Errata Sheet

Product Family:	Terminator I/O	Date:	January 2019
Manual Number	T1H-EBC-M		
Revision and Date	2nd Edition, Rev. B; May, 2014

Changes to Chapter 3. Configuring the T1H-EBC(100) Using NetEdit3

**EBC Settings>
Configuration>
General**

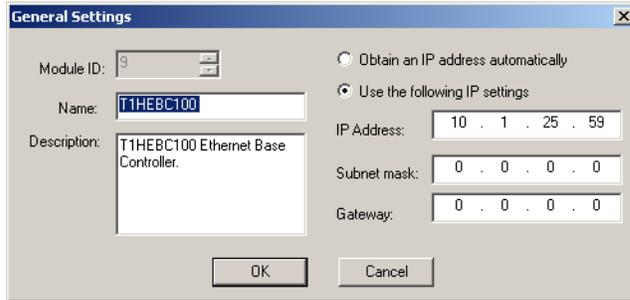
See Errata Sheet at the beginning of this file. Add this note:
NOTE: T1H-EBC100 modules have a DIP switch located under the cover on the left side. Turning this switch on will reset the IP Address, subnet and gateway to the factory defaults. (T1H-EBC modules do not have a DIP switch.)
